## COUNCIL PANEL ASSESSMENT REPORT

<b>Panel Reference</b>	2017SNH066
<b>DA Number</b>	DA 0307/17
<b>LGA</b>	Ku-ring-gai
<b>Proposed Development</b>	Demolition of a heritage item, tree removal, earthworks, construction and use of hardware building supplies development (Bunnings Warehouse), signage, landscaping, consolidation of titles. Threatened Species Development under the Species Conservation Act 1995 (NSW).
<b>Street Address</b>	950-950A Pacific Highway and 2 Bridge Street, Pymble
<b>Applicant/Owner</b>	Bunnings Properties Pty Ltd
<b>Date of DA Lodgement</b>	1 August 2017
<b>Number of Submissions</b>	2 submissions in response to 1 <sup>st</sup> notification.
<b>Recommendation</b>	Refusal
<b>Regional Development Criteria (Schedule 7 of the SEPP (State and Regional Development) 2011)</b>	CIV in excess of \$30 million
<b>List of all relevant s4.15(1)(a) matters</b>	<ul style="list-style-type: none"> <li>• SEPP 55 – Remediation of Land</li> <li>• (Draft) Remediation of Land SEPP</li> <li>• State Environmental Planning Policy No. 64</li> <li>• SEPP (Infrastructure) 2007</li> <li>• SEPP (Vegetation in Non-Rural Areas) 2017</li> <li>• Sydney Regional Environmental Plan (Sydney Harbou

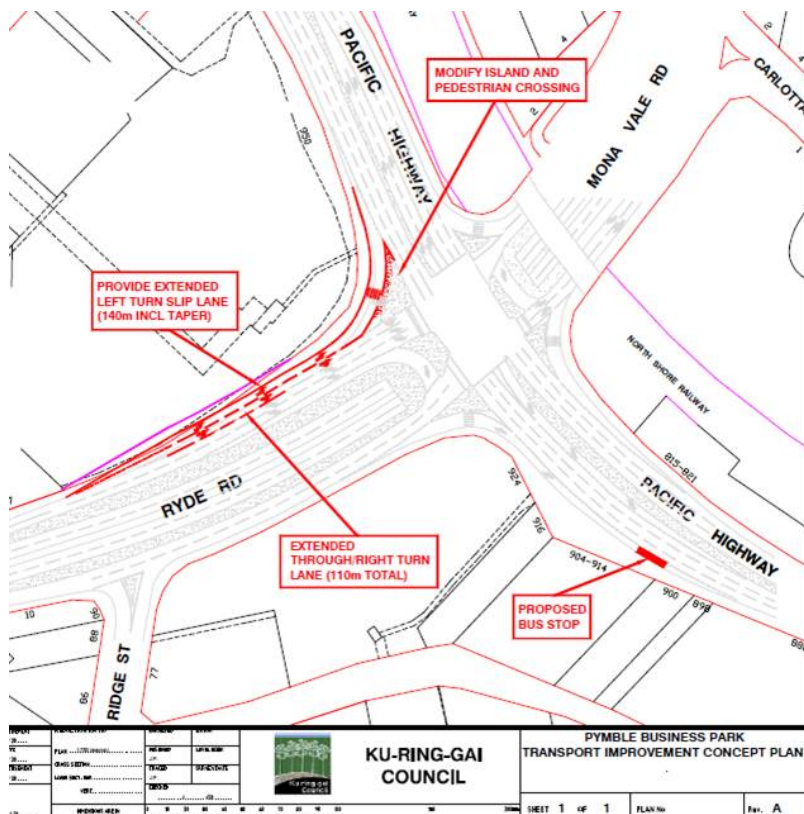
*The TTPA report (Page 8) states that it is not possible to widen the Off Ramp back to West Street due to the number of affected properties and buildings. The report*

*(Page 8) also states that "forcing the eastbound vehicles through the Pacific Highway intersection would have a significant detrimental effect on the operational performance of this major intersection and to extent defeat the purpose of the grade separated interchange."*

*Putting this together, the Court made the granting of development consent contingent on Ryde Road / West Street being converted to traffic signals. Dating back to 2011, RMS have sought investigation of alternatives to converting the intersection to signal controls, and in their letter, dated 29 March 2018, have confirmed the position that the authority does not support traffic signals at Ryde Road / West Street. The statement on Page 8 of the TTPA report (re the effect on the interchange) makes it somewhat difficult to argue that the development will have no detrimental impact on traffic if the traffic signals are not provided (i.e. send all traffic through the Pacific Highway intersection).*

*An independent review of traffic surveys, SIDRA modelling should be undertaken to test the veracity of the TTPA conclusions. It does seem that TTPA rely on the 2011 Pymble Business Park Study, which would have generated 300 additional vehicle trips during the weekday AM and PM peaks, and then apply the allowable FSR to suggest that the site could generate 1,045 (AM peak) and 784 (PM) trips, which is massively over the findings of the 2011 study. While the report doesn't explicitly state this, its seems to want to take the 2011 increase and rely on it totally for the Bunnings site, whereas it applies to the entire precinct.*
